Illinois Department of Transportation

SUBJECT: Crawford County Airport
Robinson, Illinois
Crawford County
Illinois Project Number: RSV-5265
SBG Project Number: 3-17-SBGP-TBD
Contract No. RB024
Item No. 09A, April 24, 2026 Letting
Addendum A

NOTICE TO PROSPECTIVE BIDDERS

Clarification / additional information on roof penetrations.

ARCHITECTURAL PIPE BOOT DETAIL

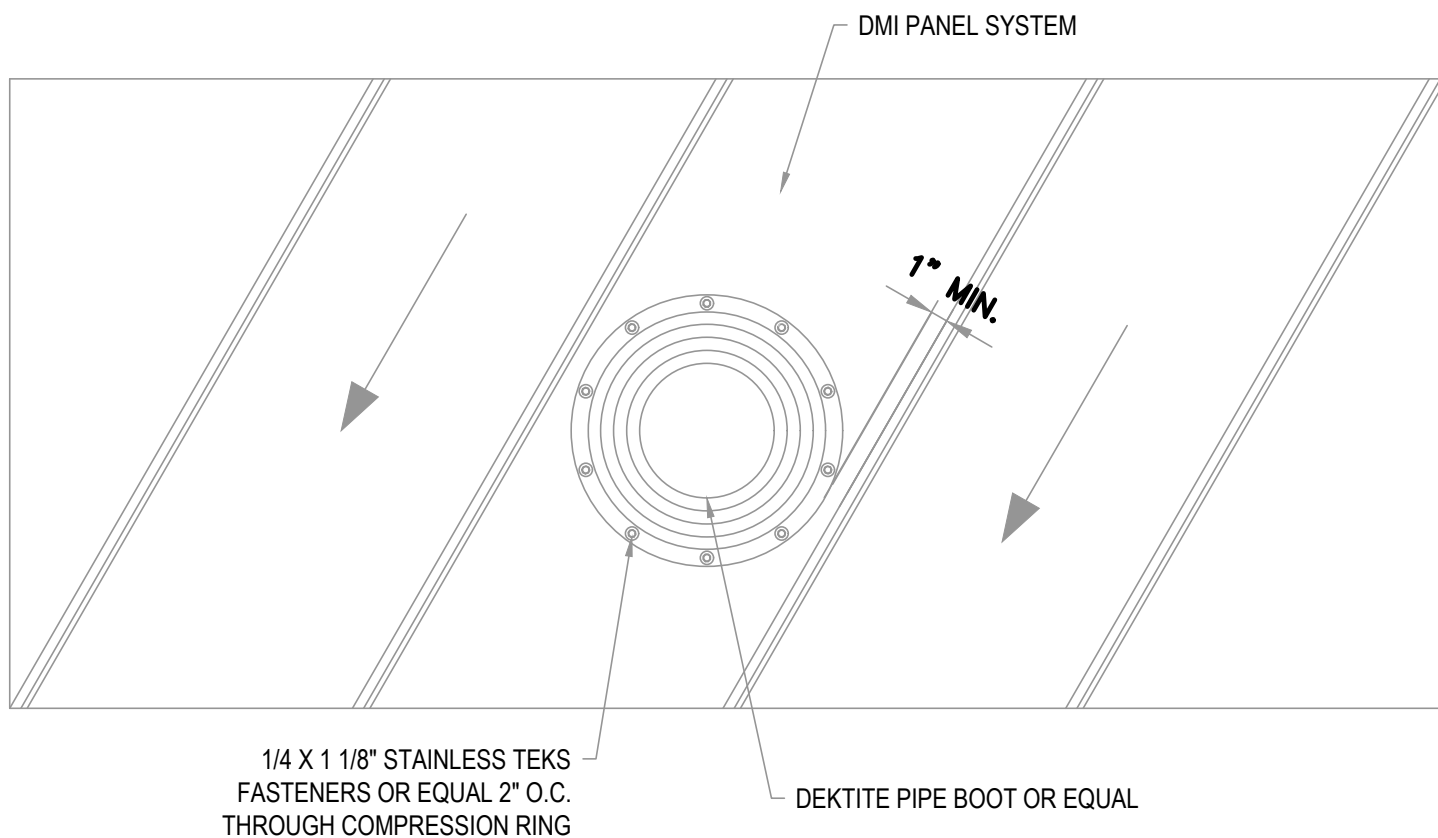
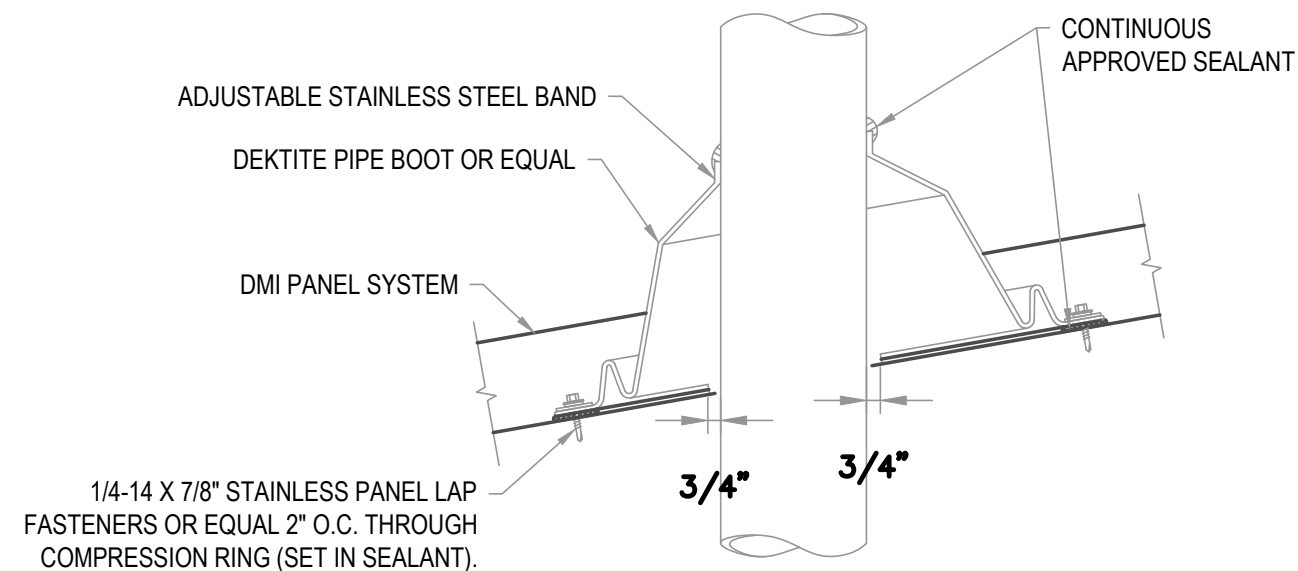
General Clarification regarding equipment installations requiring penetrations of the existing terminal building roof:

Provide equipment penetration in existing color-coated, galvanized steel, curved standing seam metal roof system. Roof consists of standing seam metal roof over 40 mil high temperature self-adhering rubber-modified asphalt underlayment over 3/4" exterior grade plywood sheathing over R-30 rigid insulation over structural metal roof deck.

Coordinate penetrations with roofing system manufacturer – Dimensional Metals, Inc. (DMI) (dmimetals.com), and roof-installing contractor – Joiner Sheet Metal & Roofing (618-664-9488) to ensure conformance to all requirements and to not void either the manufacturer's or the roof-installing contractor's warranties. Conform to the requirements of the attached architectural pipe boot detail as provided by DMI.

DO NOT ATTACH INTO SOLID SUBSTRATE BELOW.

BOOT SHALL NOT INTERSECT STANDING SEAM VERTICAL LEG. INSTALL IN FLAT AREA OF PANEL ONLY.

IF USING A SQUARE BOOT DETAIL BE SURE TO SET BOOT IN A DIAGONAL OR DIAMOND TO ALLOW WATER FLOW.
